NON-COMPLIANCE REPORT # 33413-39, 33413-110 & 33415-9

PART NAME: KINEMATIC VEE SUPPORT
 PF/SA NO.: PF-382-909-47 R0
 WORK ORDER NO.: 33413-39, 33413-110 & 33415-9
 VENDOR: GIVMAR

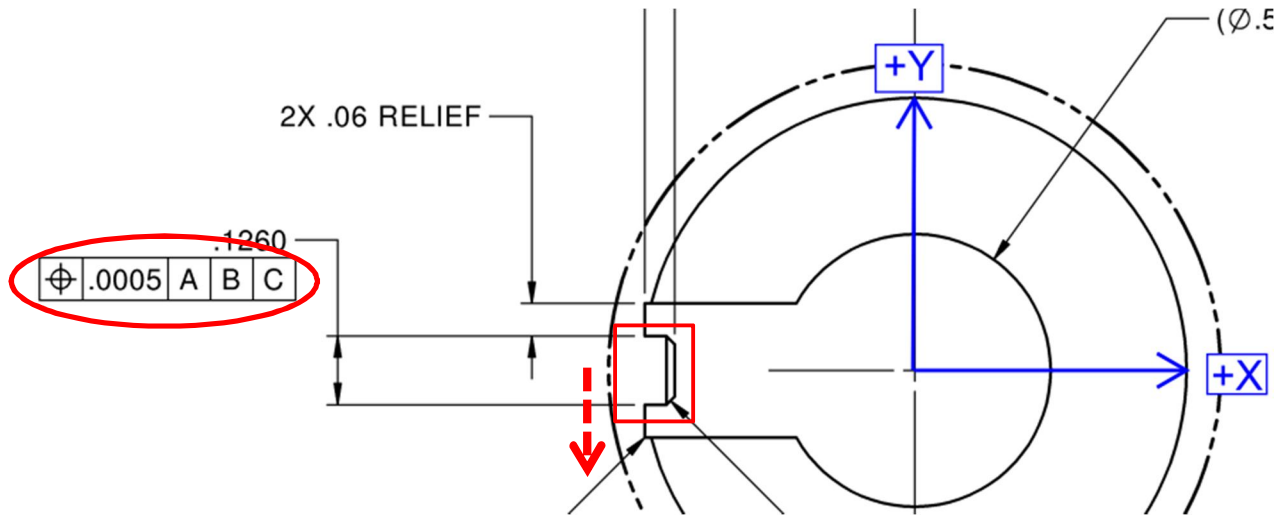
1. $\varnothing .0005$ A B C OF $.1260$ (DETAIL B) is out of position on all 12 parts ranging from 0.0036 - 0.0079".
 - a. Y symmetry of $.1260$ measures between -0.0018 to -0.0039 (all on the -Y direction).
